Your Ref
OL/TH/16/0550
Our Ref
PLAN-014212
Date
08/07/2016

Site: Manston Airport, Manston Road, Manston, Ramsgate, CT12 5BL.

OL/TH/16/0550

O.S. REF: TR3466NW

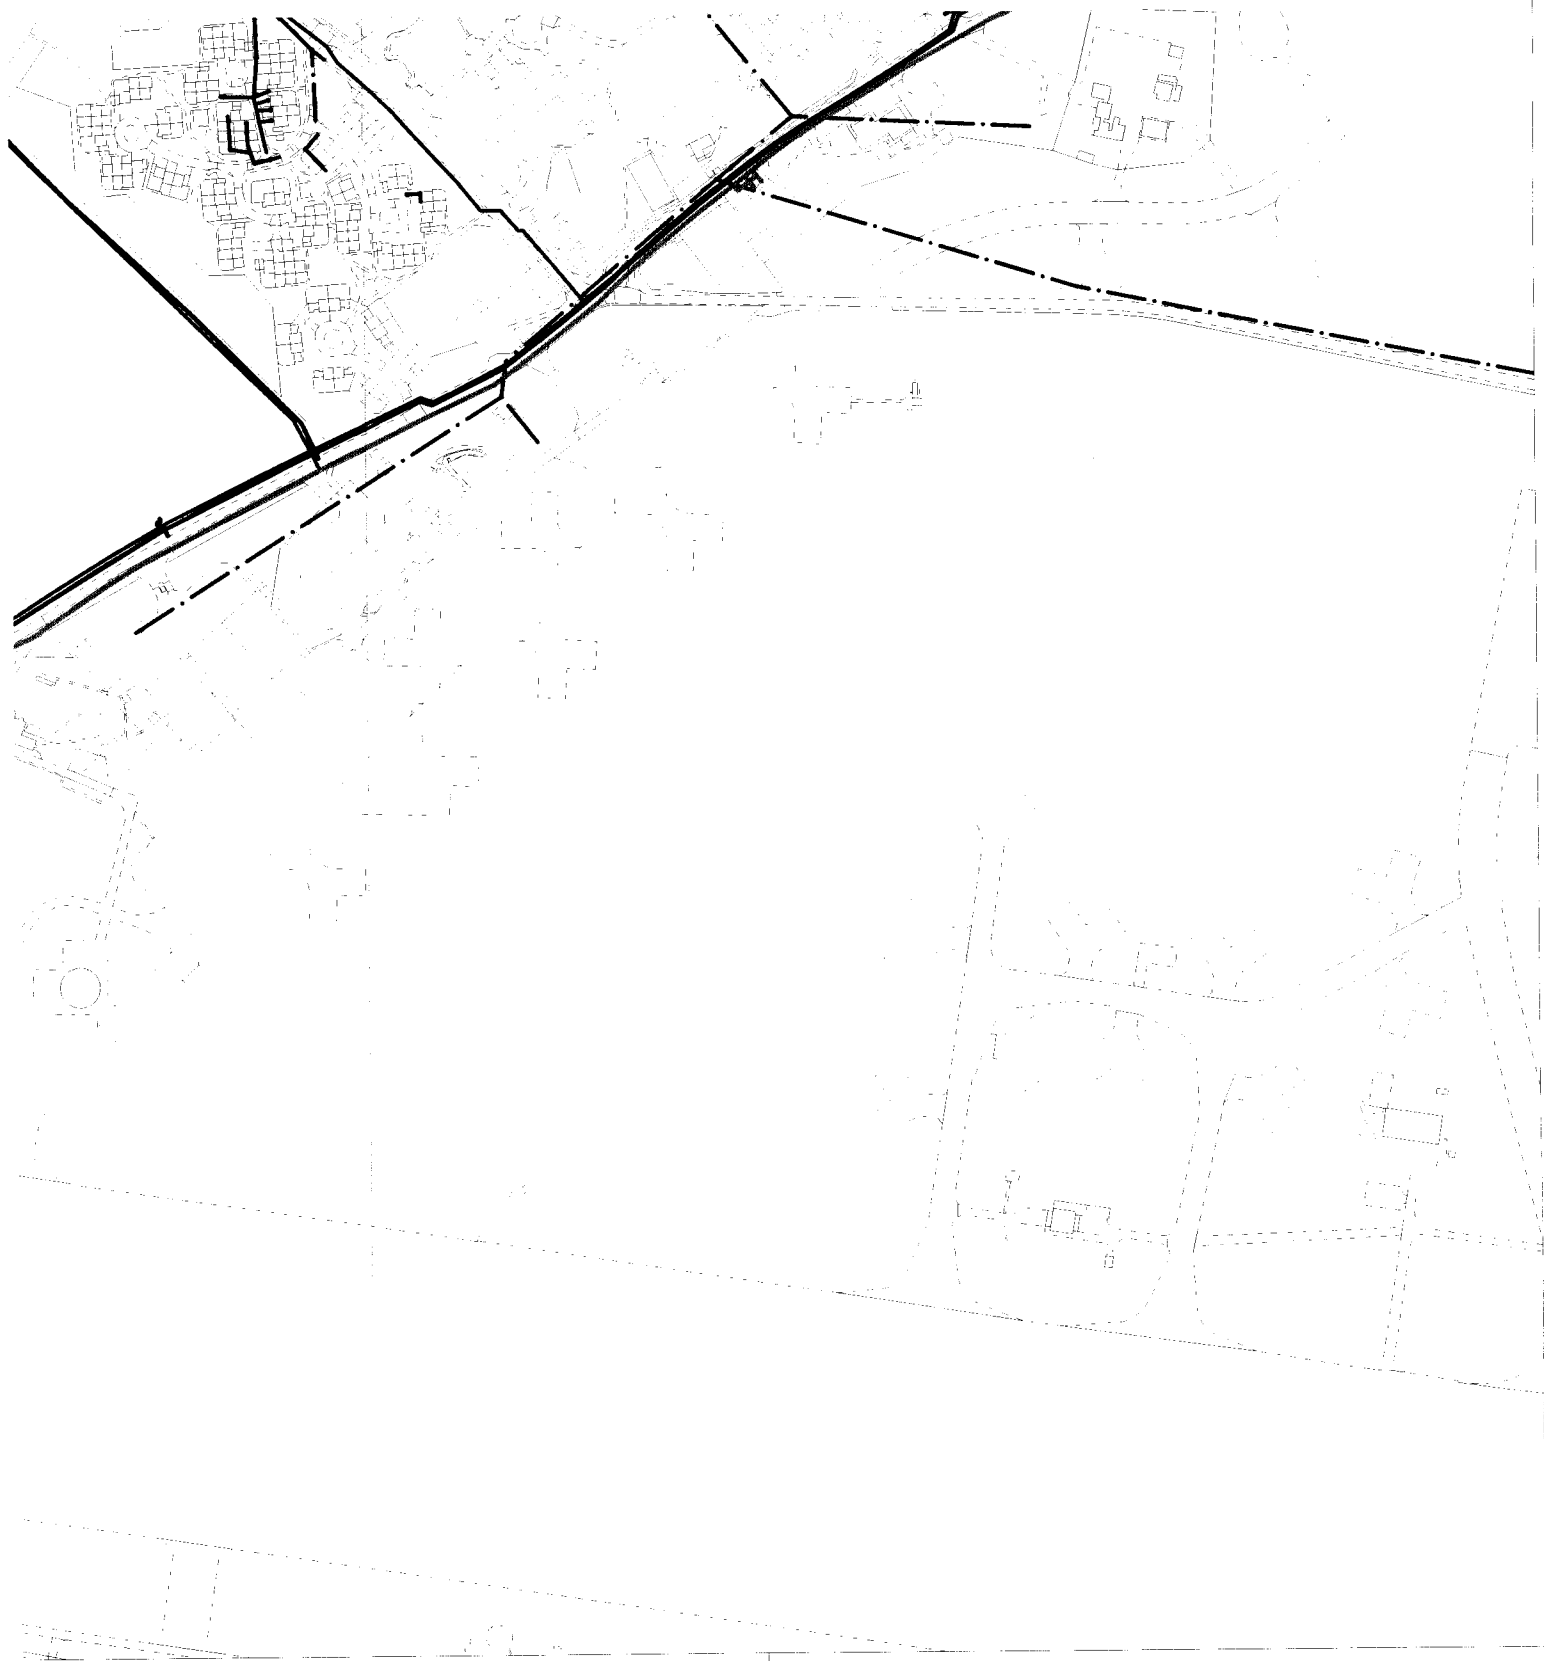
Please find attached a plan of the sewer records showing the approximate position of a public foul sewer, foul rising, water trunk main and distribution main crossing the site. The exact position of the public sewers must be determined on site by the applicant before the layout of the proposed development is finalised.

It might be possible to divert the public sewer foul sewer, foul rising, water trunk main and distribution main, so long as this would result in no unacceptable loss of

1. The 20 inch and 600mm diameter trunk main requires a clearance of 6 metres either side of the trunk main to protect it from construction works and allow for future access for maintenance.

2. The 7 inch, 6 inch, 9 inch and 125mm diameter distribution main requires a clearance of 4 metres either side of the distribution main to protect it from construction works and allow for future access for maintenance.

3. The 800 mm diameter foul rising requires a clearance of 5 metres either side of the sewer to protect it from construction works and allow for future access for maintenance.

4. The 12 inch water distribution main requires a clearance of 5 metres either side of the trunk main to protect it from construction works and allow for future access for maintenance.

5. The 225 mm and 150mm diameter foul sewer requires a clearance of 3 metres either side of the sewer to protect it from construction works and allow for future access for maintenance

6. No development or new tree planting should be located within the required clearance distance.
7. No new soakaways should be located within 5 metres of a public drainage and water apparatus.
